CHATHAM AREA TRANSIT AUTHORITY IFB 2024-06, ADDENDUM NO. 1

PROJECT: CAT Hybrid Ferry Vessels

Questions posed during initial Q&A Period and CAT's Responses:

Response: See Plans attached #22-1477-5000 - 5002.

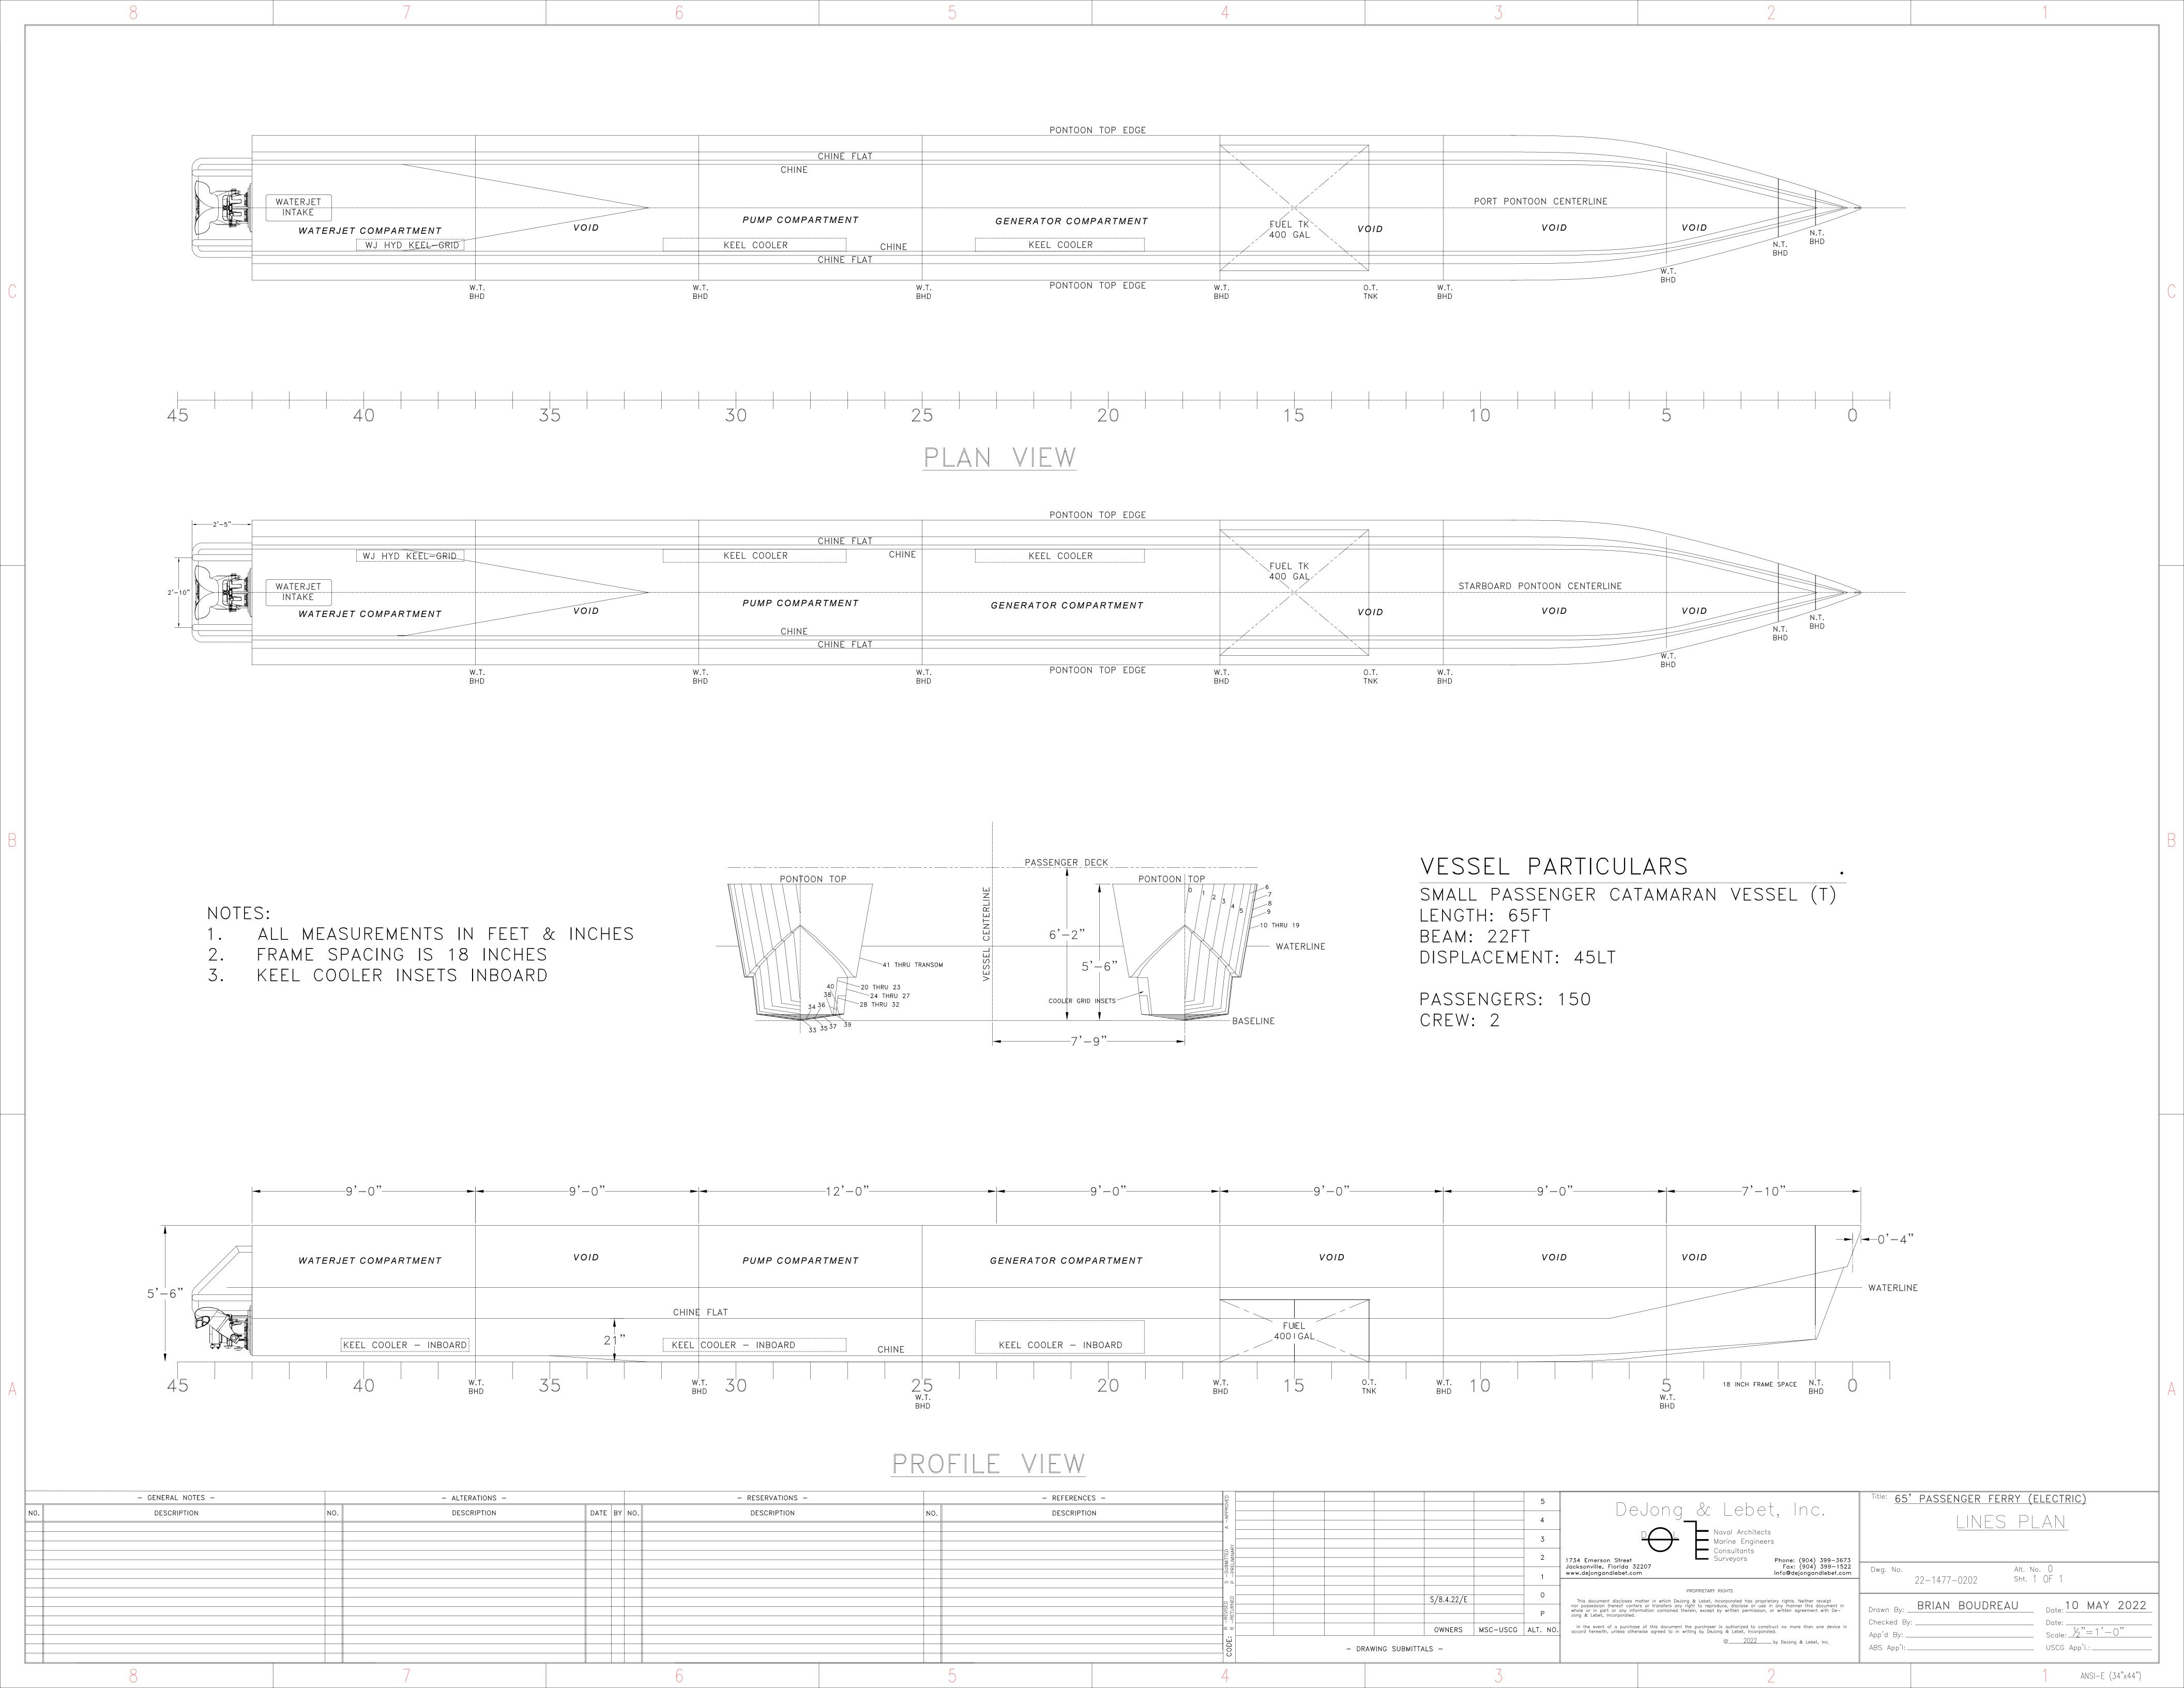
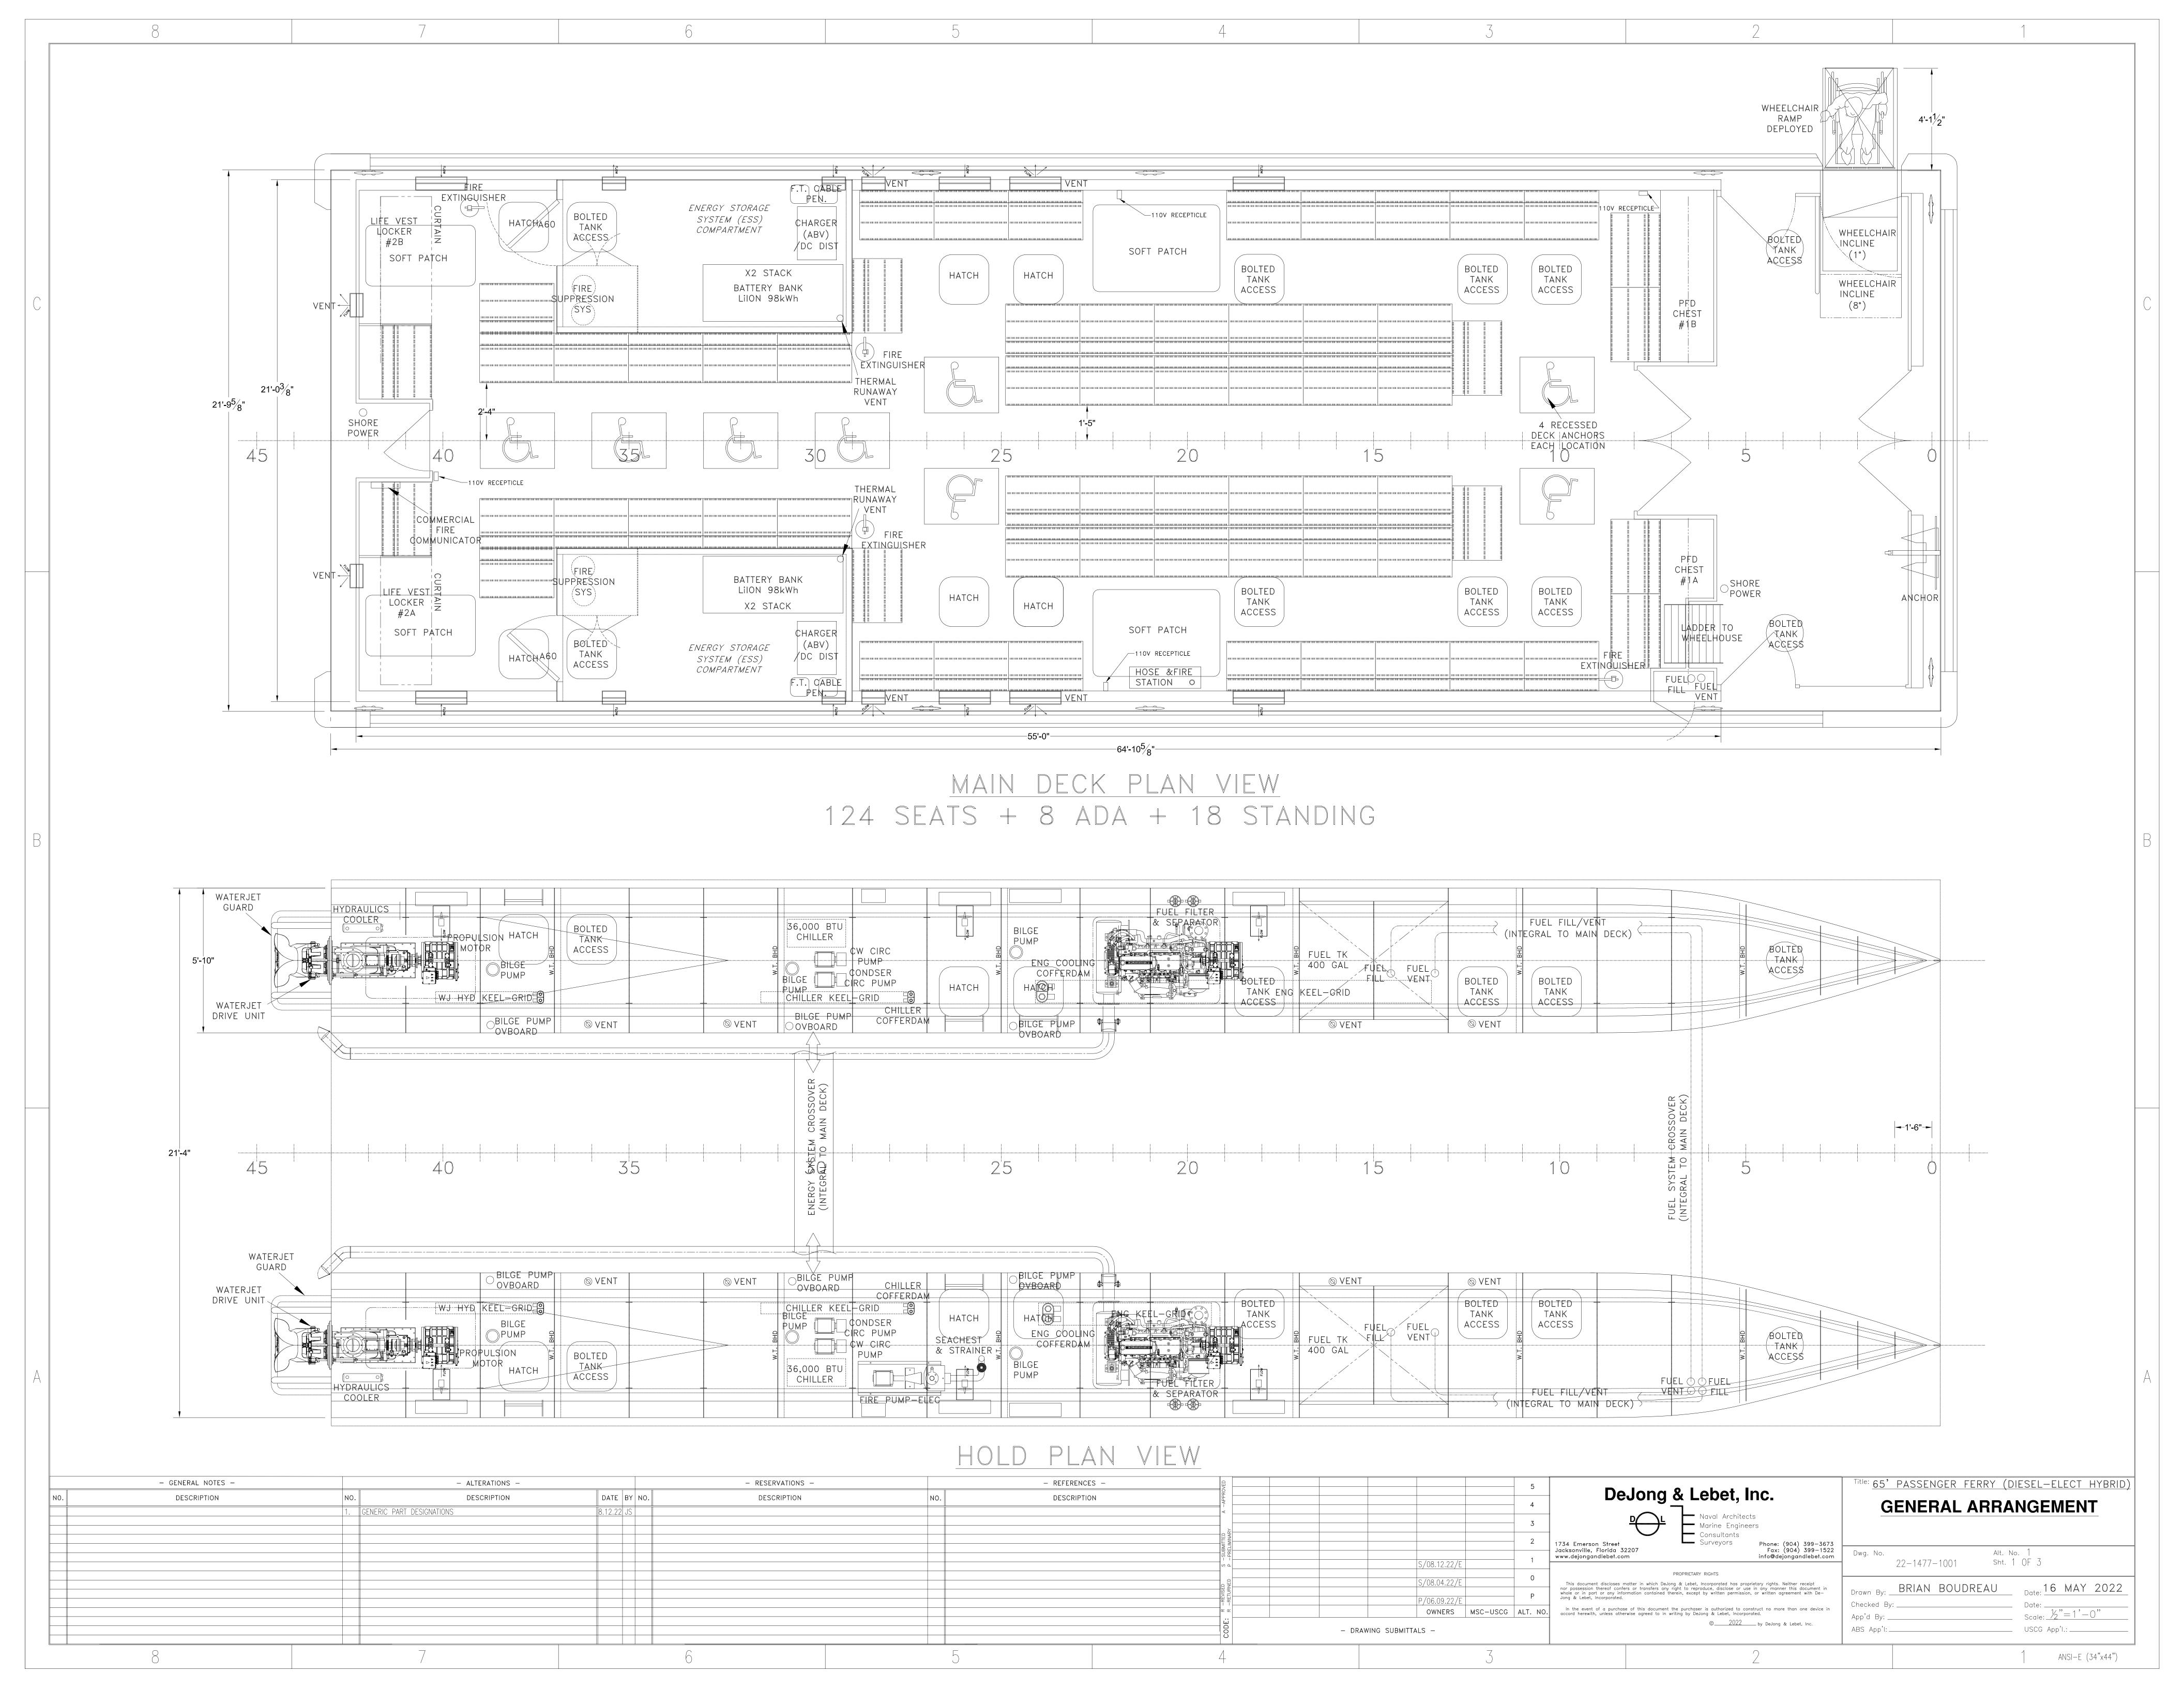
Question 9: Can you please provide me with Dwg. #22-1477-5001 & 5002 that is referenced

in the outline specifications for the 65'X21'-4" Passenger Vessel.
